Subject: Review of O'Connor Environmental, Inc. (OEI) Reports for the Little North Fork Gualala River, Timber Harvest Plan (THP) 1-18-095 MEN

## **1. Comments on Floodplain Study Report (March 21, 2019)**

Figure 1: Area-normalized runoff rates for annual maximum peak flow.

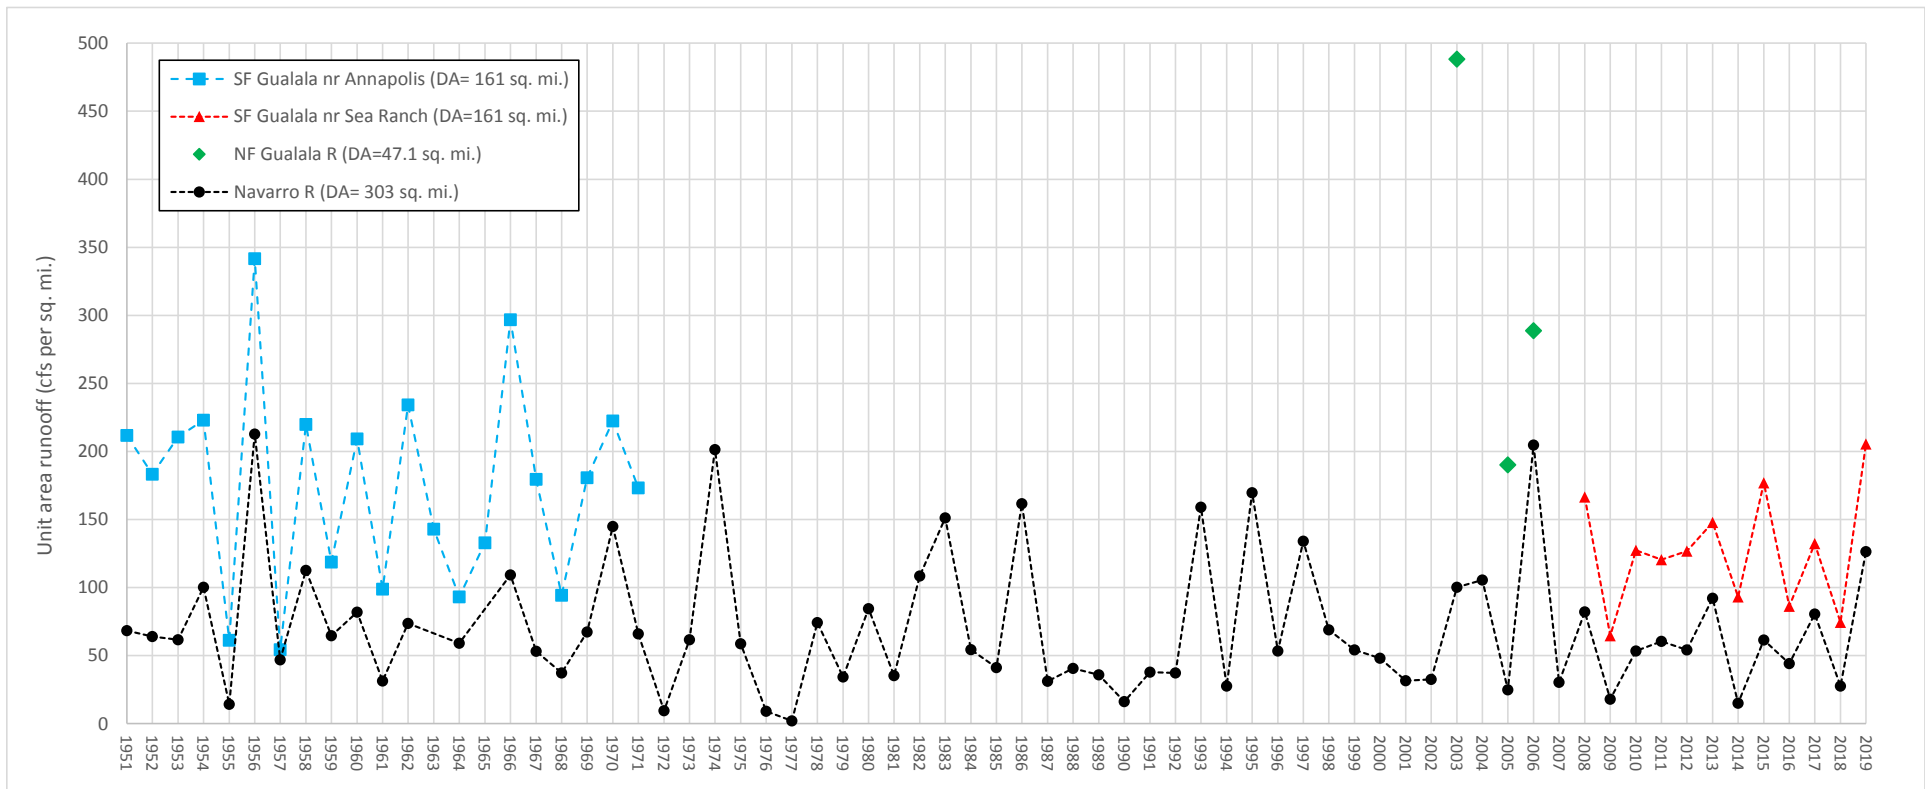
Comparison of historic annual peak flow data between the Navarro River and other Gualala River gauges contradicts the determination that area-normalized runoff rates for the Navarro River are representative of the Gualala River. Figure 1 plots area-normalized runoff rates for the Navarro (USGS 11468000), South Fork Gualala near Annapolis (USGS 11467500), South Fork Gualala River near the Sea Ranch (USGS 11467510) and North Fork Gualala River (USGS 11467553) gauges. These data indicate that unit runoff rates for the Gualala River gauges are consistently greater than those computed for the Navarro River gauge. This indicates that using area-normalized runoff rates from the Navarro River will significantly underestimate flow rates in the Gualala River watershed.

**Figure 2: Flood frequency curves of area-normalized runoff rates for the Navarro near Navarro (USGS 1146800) and combined data for the South Fork Gualala River near Annapolis (USGS11467500) and South Fork Gualala River near the Sea Ranch (USGS 11467510).**

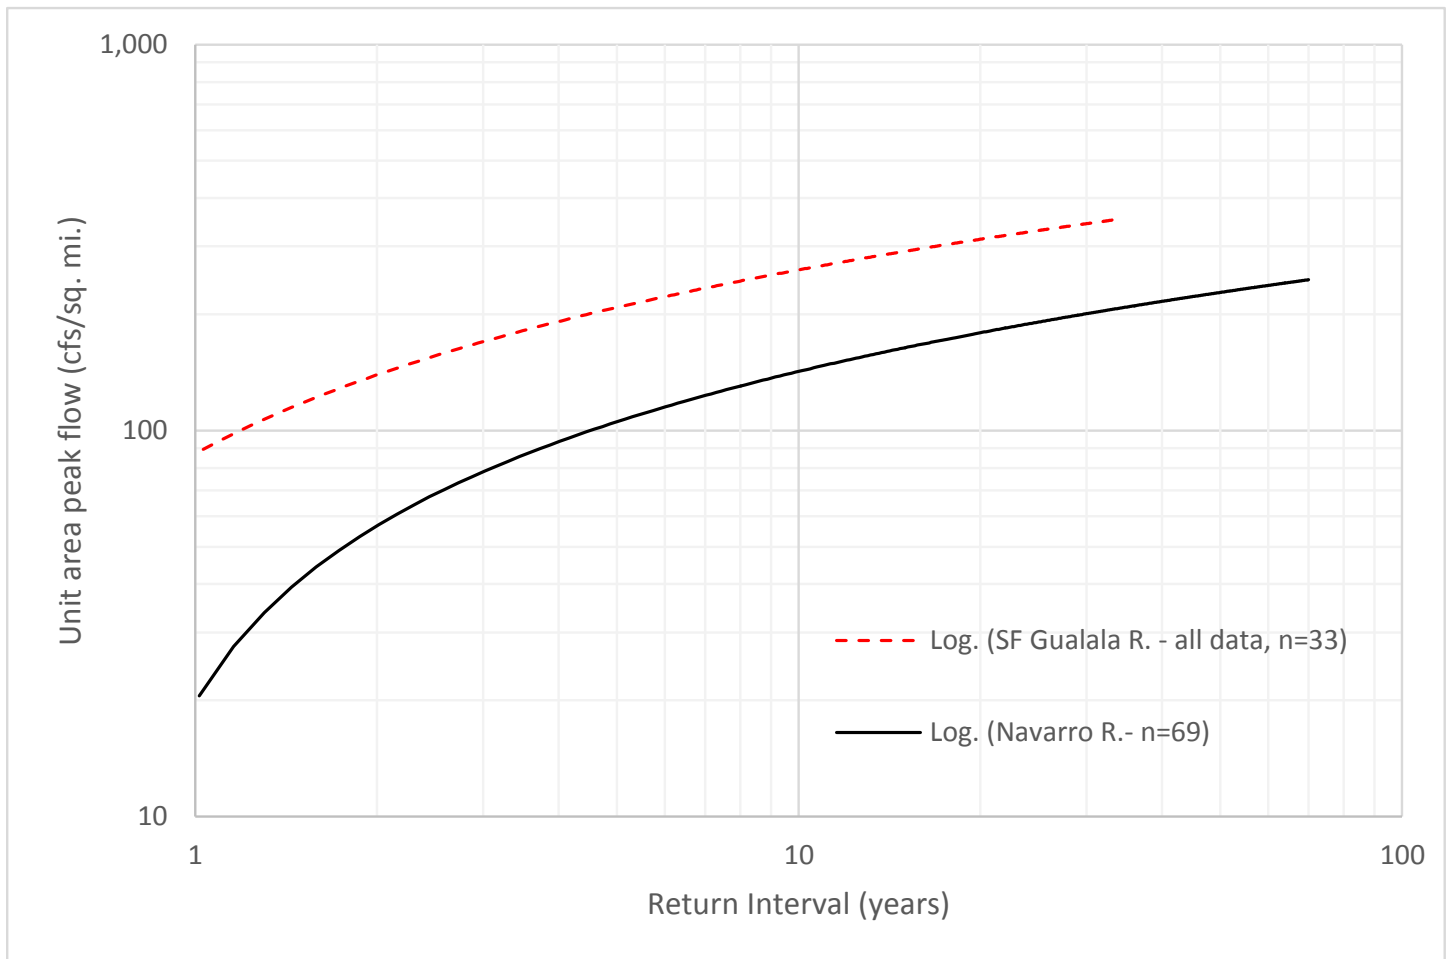
In order to demonstrate and quantify the difference in peak flow rates from the Gualala and Navarro River watersheds during storms of the same recurrence interval, Figure 2 was prepared, which plots flood frequency curves for area-normalized discharge (cfs/mi<sup>2</sup>)

The flood frequency curves presented in Figure 2 indicate that for any given recurrence interval, area-normalized peak flows on the South Fork Gualala River are significantly larger than those computed for the Navarro River. Table 1 presents selected area-normalized discharge rates for peak flows with recurrence intervals from 2- to 100-years<sup>5</sup>. As part of their hydraulic model development for the project, OEI estimated a 20-year discharge of 1,263 cfs for the 7.3 square mile Little North Fork watershed using the 173 cfs/mi<sup>2</sup> area-normalized discharge rate calculated for the Navarro River. However, this rate is significantly lower than the 20-year recurrence interval discharge rate of 313 cfs/mi<sup>2</sup> estimated for the South Fork Gualala River. Assuming the South Fork Gualala River area-normalized discharge rates are a better estimate of flow conditions on the Little North Fork, the peak flow used in OEI's floodplain inundation modeling is representative of a discharge having a recurrence interval falling somewhere between 2.5- and 5-years, not a 20-year event.

Elsewhere in their March 2019 report (page 366.10), OEI states that the area-normalized discharge (207 cfs/mi<sup>2</sup>) for the February 19, 2019 storm event on the South Fork Gualala River (33,400 cfs) is representative of a 35-year event. However, comparing this area-normalized discharge to the South Fork Gualala River flood frequency estimates presented in Table 1, suggests the February 2019 peak flow event has a recurrence interval of only 5 years. This also calls into question OEI's conclusion that the backwater elevation of the February 26, 2019 event at the USGS's North Fork gauge is a “conservative estimate” of a 20-year event, when this event is only a 5-year event. Thus, in addition to underestimating the 20-year discharge used in their floodplain study, the downstream backwater boundary condition used by OEI in their hydraulic modeling is representative of a 5-year event, not a 20- to 35-year event. Therefore, the findings and

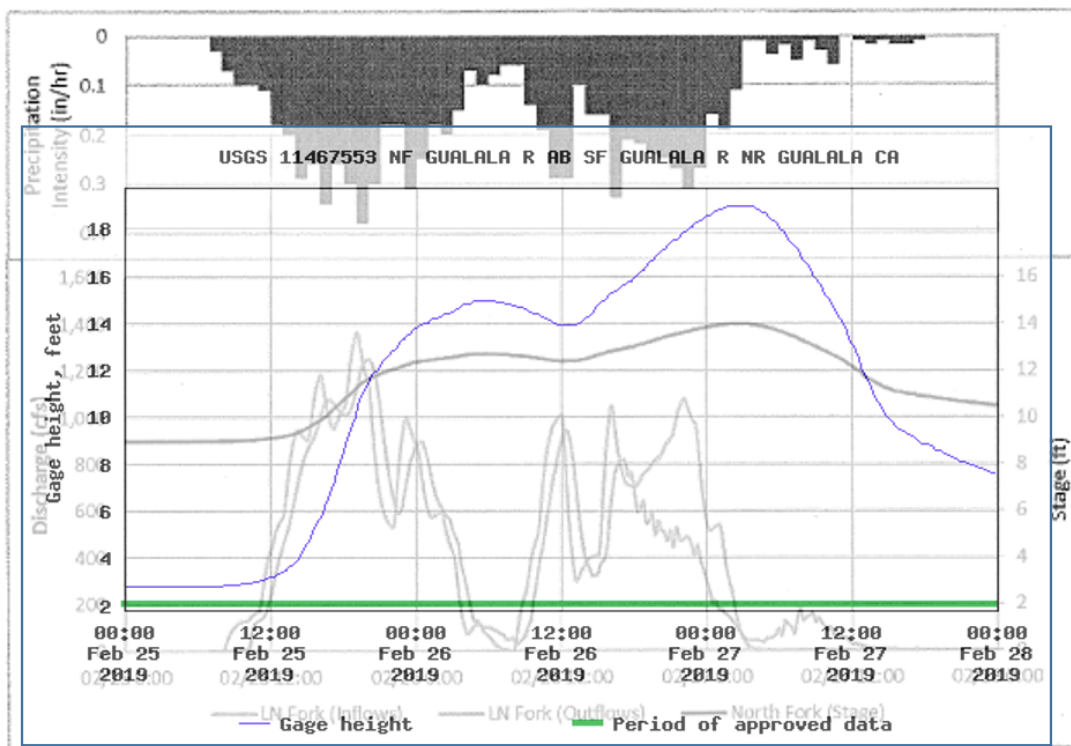
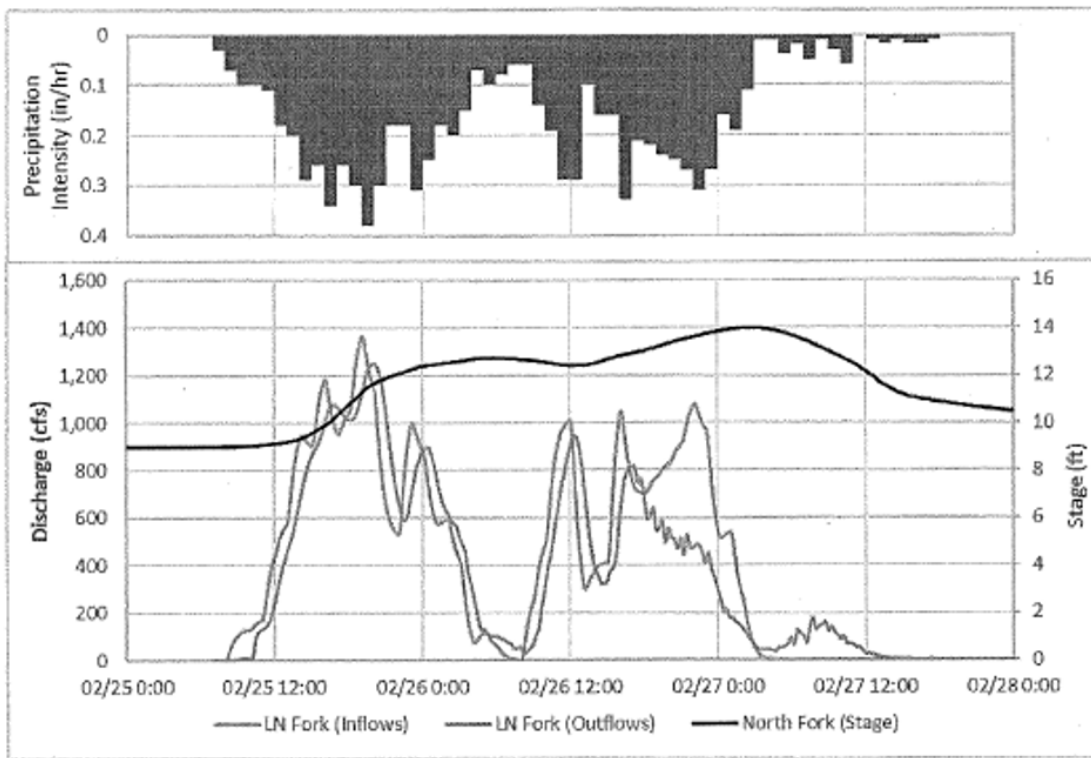
Because the OEI floodplain inundation duration study uses the same peak flow and downstream backwater boundary conditions as the model described in the March 2019 report, this study underestimates the peak flow and water level boundary conditions. As a result, their unsteady state modeling underestimates the area and duration of inundation experienced during peak flow event having a 20-year recurrence interval. In addition to the comments provided above on the March 2019 report, this conclusion is supported by comparing modeled versus measured water levels at the USGS North Fork Gualala River gauge. Figure 4 of OEI’s July 2019 report presents simulated stage for the North Fork gauge in addition to simulated inflows/outflows on the Little North Fork and modeled precipitation intensity. Figure 4 of this letter report presents OEI’s Figure 4 and superimposes the measured water levels (gage height) for the North Fork gauge as reported by the USGS over the model period. Comparison of the modeled “stage” and measured “gage height” indicates the OEI model underestimates the peak water level at the USGS gauge by 5-feet (simulated maximum level of 14 feet vs. measured maximum level of 19 feet). Conversely, the model estimates the baseflow water levels prior to the storm at 9 feet, whereas the measured water levels were less than 3 feet. This comparison of simulated versus measured water levels indicate the model is underestimating inundation levels and durations at the lower end of the modeled project reach (there is no water level monitoring data available for comparison to simulation results in upstream portions of the model). Given the model inflow boundary condition is significantly less

than the 20-year recurrence event, it is not surprising the model significantly underestimates water levels as presented in Figure 4. Therefore, the findings and conclusions presented in the July 2019 report should be considered inaccurate as they do not represent a peak flow event with a 20-year recurrence interval.
